10/642,708

Office Action Summary	Application No. 10/642,708	Applicant(s) WERNING, JASON	
	Examiner Kristina R. Gluchowski	Art Unit 3676

DETAILED ACTION

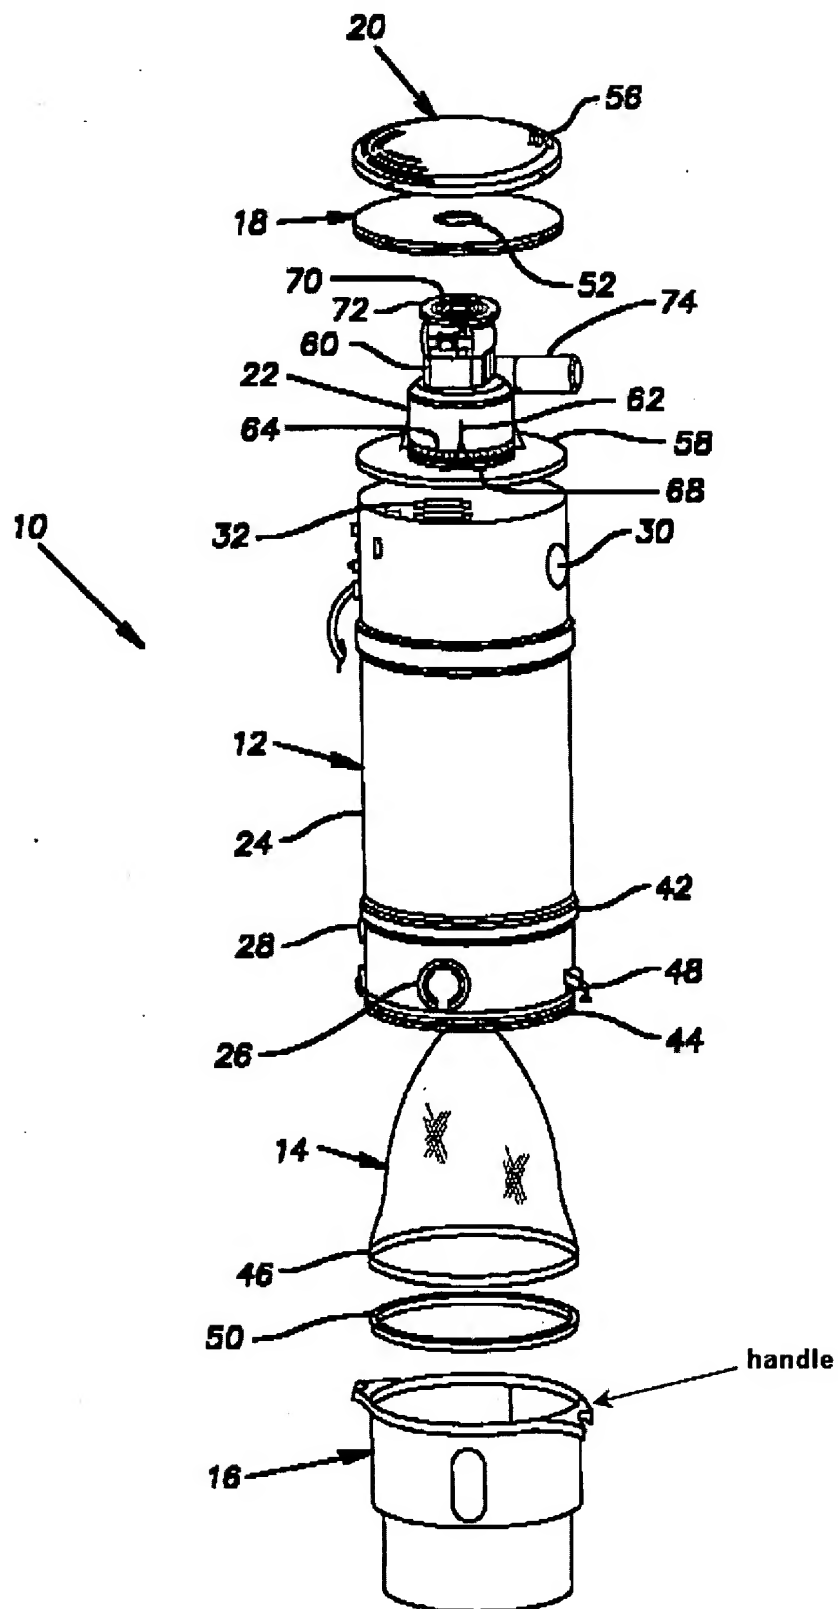
3. Regarding claims 1, 19, 21, 23, Fritz shows a locking mechanism for a central vacuum system with a debris receptacle (16) and a canister (12), the locking mechanism comprising a vertical gasket (50) to facilitate an airtight seal between the debris receptacle and the canister of the central vacuum system and a twist-lock latch (48) configured to guide a handle (see illustration below) portion of the debris receptacle to a lock position (the attached position is considered a lock position; see column 3, lines 25-30) between the twist-lock latch and the vertical gasket (see figure 1, the handle portion is between gasket 50 and bottom portion of latch 48). The examiner would like to note that a "twist-lock latch" could be any latch. The term "twist-lock" is considered a label in claim 1 since no further structure of the twist lock latch is claimed.

4. Regarding claims 2 and 24, the latch comprises a contoured ramp (curved guide portion of latch, see illustration below) "configured to" guide the handle portion of the debris receptacle to the lock position.

5. Regarding claim 3, the latch comprises a stop detent (hook portion on bottom to engage handle, see illustration below) to fully engage the debris receptacle into the lock position.

6. Regarding claim 8, the vertical gasket includes a bead roll (see illustration below; lower portion of gasket), configured to be received by a groove (44) formed in an exterior surface of the canister (column 3, lines 30-32).

7. Regarding claim 20, Fritz shows two latches (48) on opposing sides of the canister (see figure 1). See the Fritz device below.

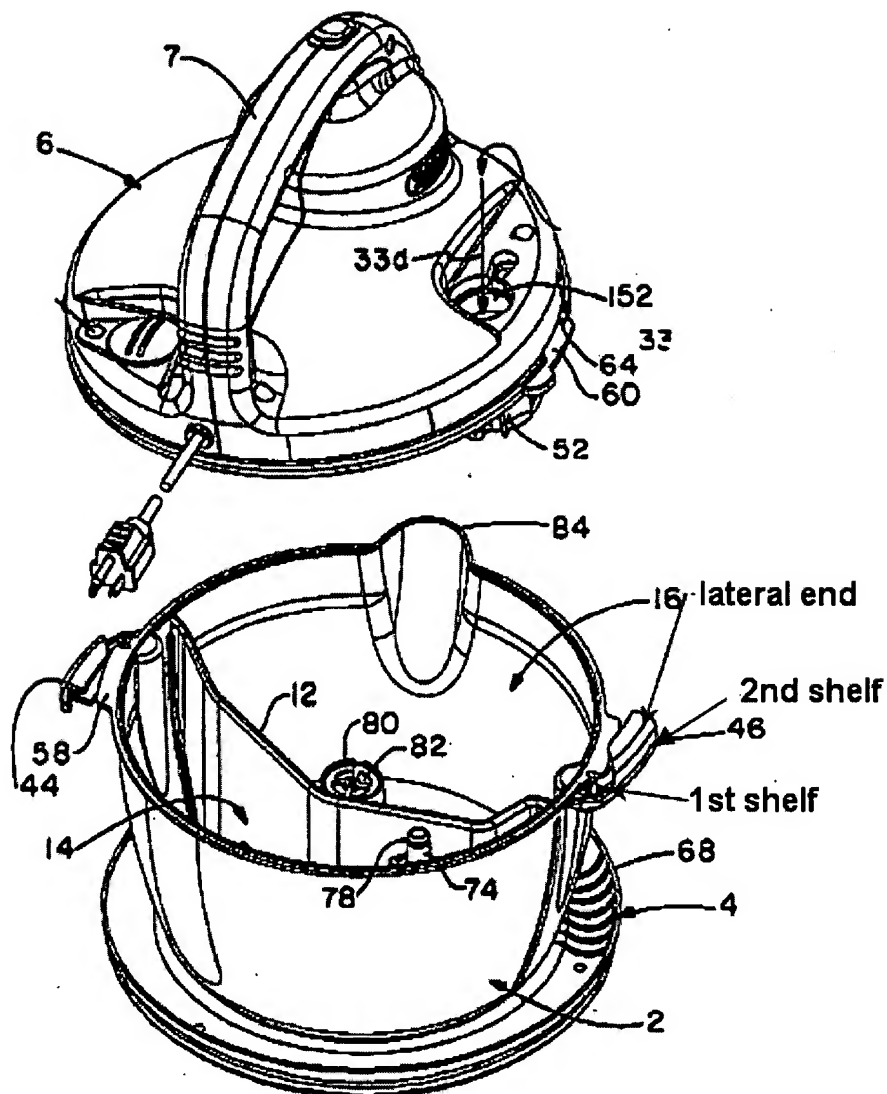
11. Regarding claims 9, 22 and 25-28, Fritz shows a canister and receptacle with a handle portion and latch as applied to claim 1 above. Crouser shows a latch attaching the debris receptacle (2) to the upper portion (6) wherein the latch has a first shelf portion (see illustration below) and an open lateral end portion (see illustration below) "configured to" laterally receive the handle portion of the debris receptacle from a portion outside the canister and a stop detent (handle hits round portion of latch; see figure 3) to facilitate proper engagement of the handle portion in the lock position.

12. Regarding claim 10, Fritz in view of Crouser, Crouser shows a second shelf portion (see illustration below). It would have been obvious to one of ordinary skill in the

art at the time of the applicant's invention to include a second shelf portion to prevent damage to the gasket as a result of repetitive use of the latch.

13. Regarding claim 11, Fritz in view of Crouser, Crouser shows a contoured ramp (54) "configured to" guide the handle portion of the debris receptacle into place.

14. Regarding claim 12, Fritz in view of Crouser, Crouser shows the latch is "configured to" be coupled to the canister portion of the central vacuum system via a fastener (post 40).

15. Regarding claim 13, Fritz in view of Crouser, Crouser shows a latch with no moving parts. The latch as a whole rotates but the latch itself does not contain moving parts as claimed.

16. Regarding claims 9-13, 22 and 25-28, it would have been obvious to one of ordinary skill in the art at the time of applicant's invention to replace the latch of Fritz with the latch of Crouser since replacing one latching means for another is considered to be within the level of ordinary skill of a worker in the art. Both latching means accomplish sealing a a receptacle to a top portion (canister). Replacing the Fritz latch with the Crouser latch would increase ease of use for the device in that the latching and unlatching motion would be reduced to a simple rotation as opposed to holding the canister in place and snapping each latch separately. See the Crouser device below.
